**Affected Products - RACM150-S/F Series**

We herewith inform you that an EOL (end of life) notification from our fan supplier has forced us to change to a different fan model and this will increase the height of the fan and therefore the height of the product by 1.5mm.

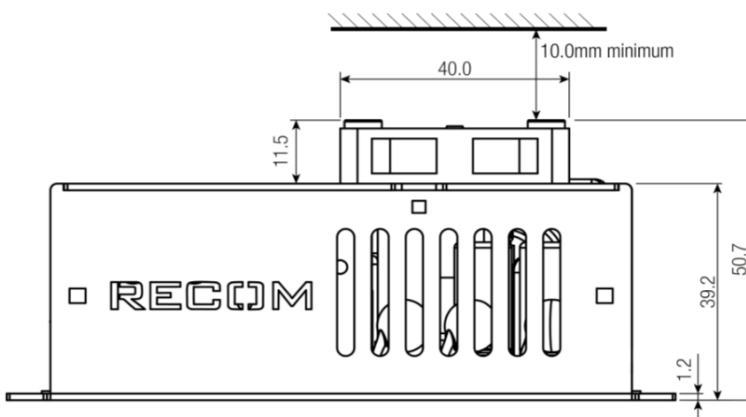
Details about the change:

*Old Drawing:*

*New Drawing:*
